CERTIFICATE OF APPROPRIATENESS

Property: 8734 Glenloch Drive, Lot 4, Block 52, Glenbrook Valley Section 9 Subdivision. The property includes a historic 2,282 square foot, one-story brick veneer single-family residence with attached garage situated on a 9,040 square foot (80' x 113') corner lot.

Proposal: Alteration – In July 2014 the applicant replaced 14 original aluminum single lite fixed windows, 2 and 3-part single lite slider windows with 11, 9-lite slider, 6-over-6 sash windows, and a 3-part bay window, replaced the front entry door with a 9-lite front entry door, installed inoperable shutters, and replace the sectional overhead garage door with a new garage door without a City Permit or Certificate of Appropriateness.

Recommendation: Approval with conditions:

NORTH SIDE ELEVATION

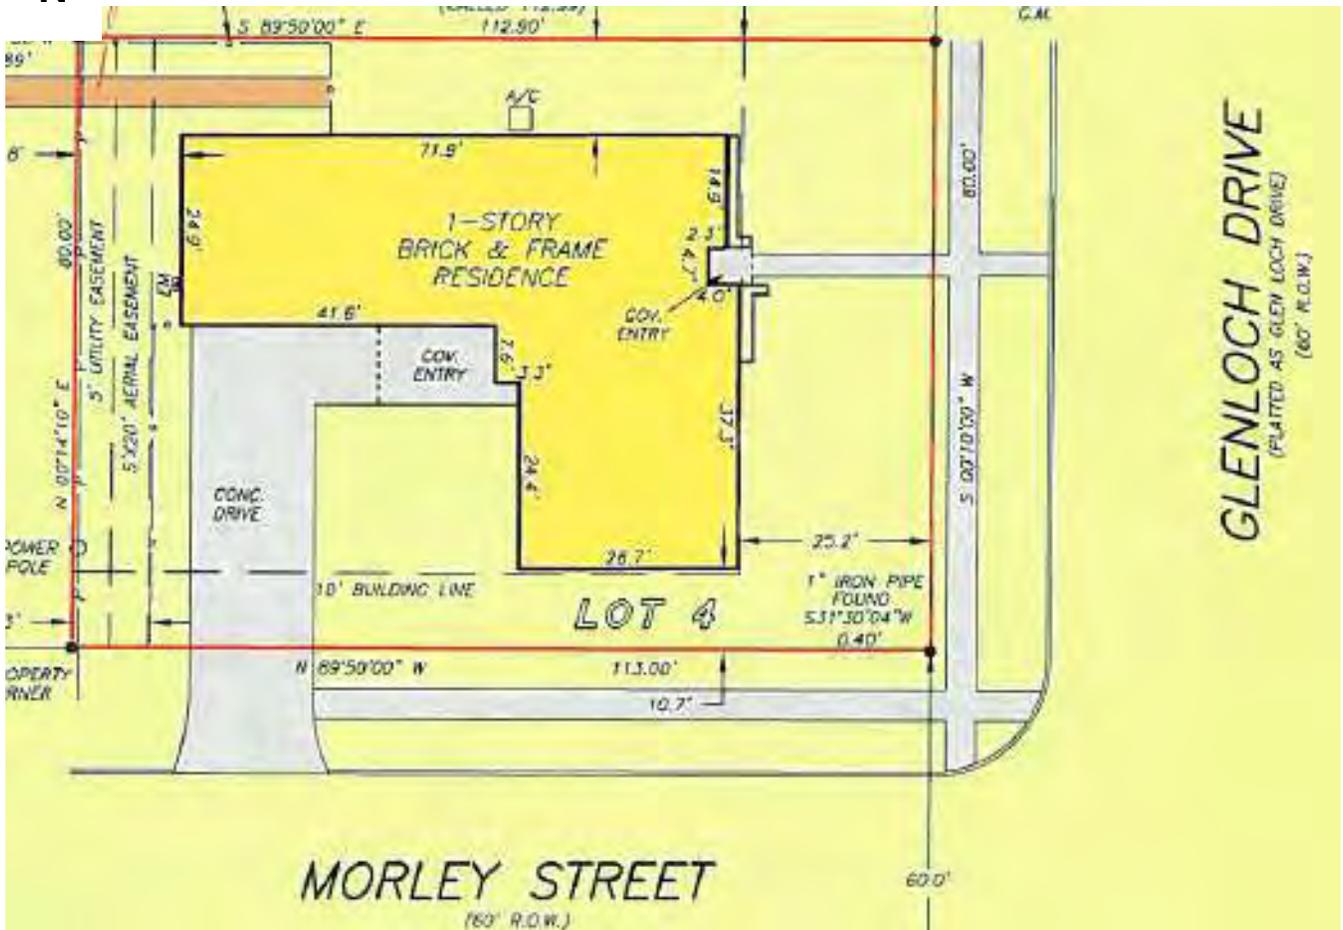
<i>The removal of the original aluminum windows and entry door results in the loss of historic material. The new divide lite windows along with the installation of the bay window alter the historic character of the Traditional Ranch.</i> |

<i>The installation divided lite craftsman style windows, shutters and bay window introduces new architectural features that are not compatible with and alter the character of the 1959 Traditional ranch.</i> |

<i>The removal of the original single lite windows and solid entry door results in the significant loss of historic materials. The new divided lite windows with shutters along with the installation of the bay window introduce new architectural features and are not compatible with the historic character of the 1959 Traditional Ranch.</i> |

Replace the existing 9-lite slider and divided lite sash windows with single- lite slider windows and 1-over-1 sash windows, remove the bay window and install 3, single lite windows to match the original condition; remove the inoperable shutters.

FIRST FLOOR PLAN WITH WINDOW LOCATIONS

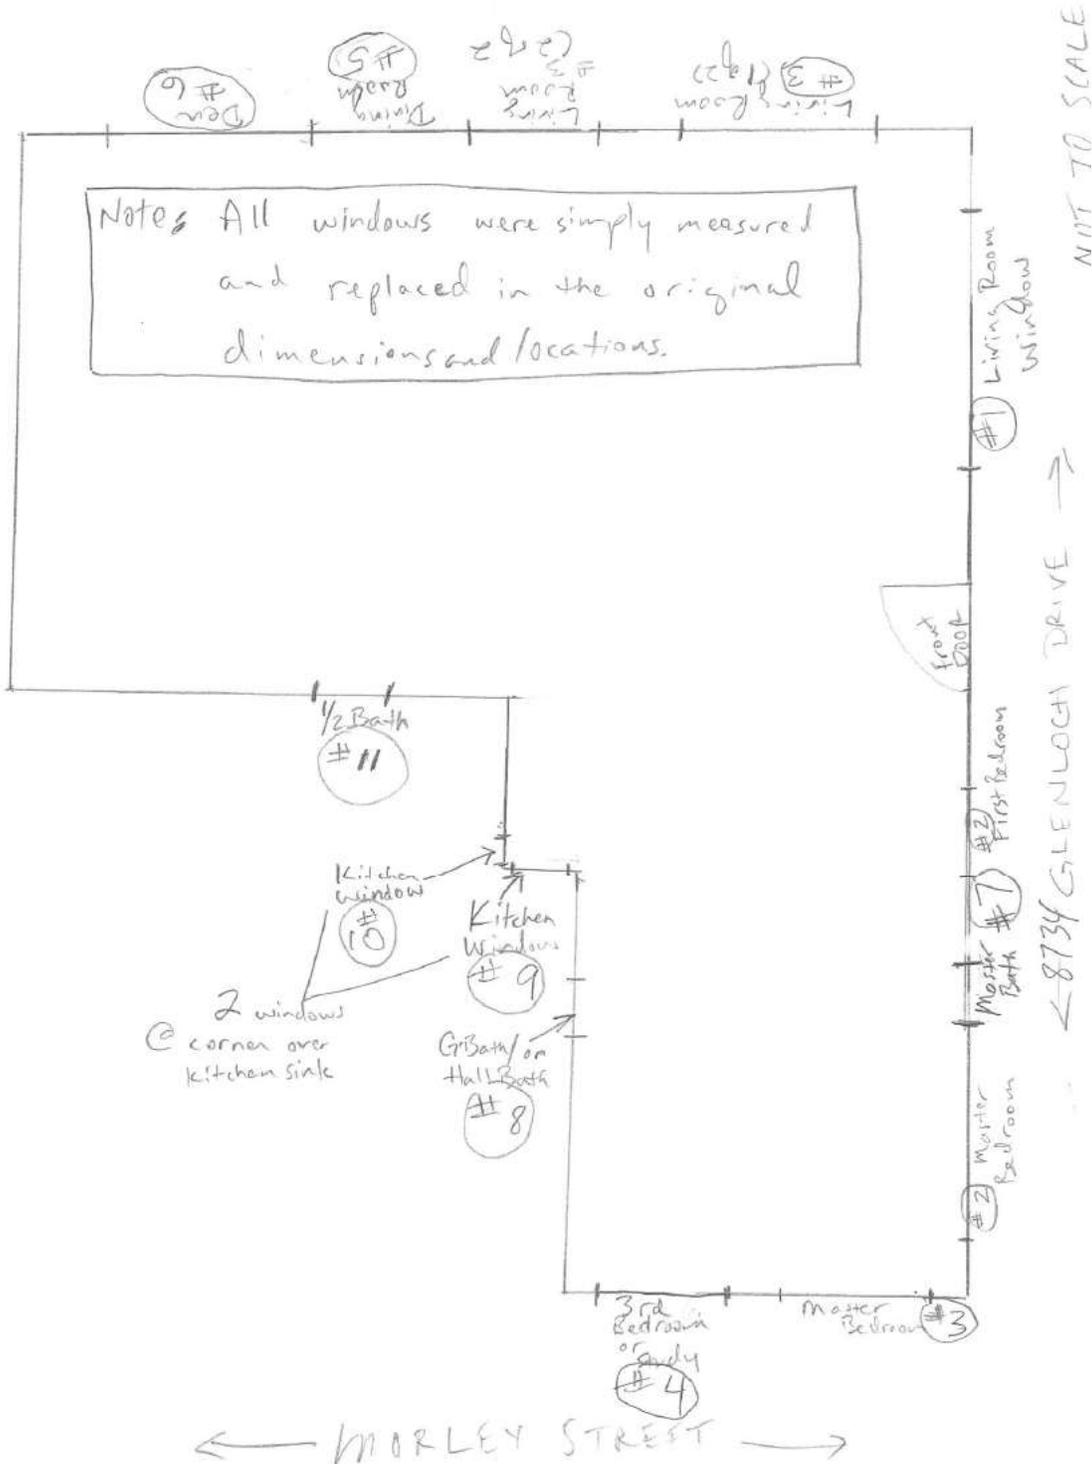
Front Elevation: Three single lite fixed windows were replaced with a 3-part bay window consisting of two 9-over-9 sash windows and a 9-lite picture window. The solid entry door was replaced with a 9-lite entry door. Two, 3-part windows were replaced with two 3-part 9-lite slider windows; a fixed window was replaced with a 6-over-6 sash window.

Side Elevation: A 2-lite slider window was replaced with a 2-part 9-lite slider window; a 3-part slider window was replaced with a 3-part 9-lite slider window. Two fixed windows were replaced with two 6-over-6 sash windows. The sectional overhead garage door was replaced with a new metal sectional overhead garage door,

Side Elevation: Two 3-part slider windows were replaced with two 3-part 9-lite slider windows; a 2-lite slider window was replaced with a 2-part 9-lite slider window.

Rear Elevation: Two single lite fixed windows were replaced with two 6-over-6 sash windows.
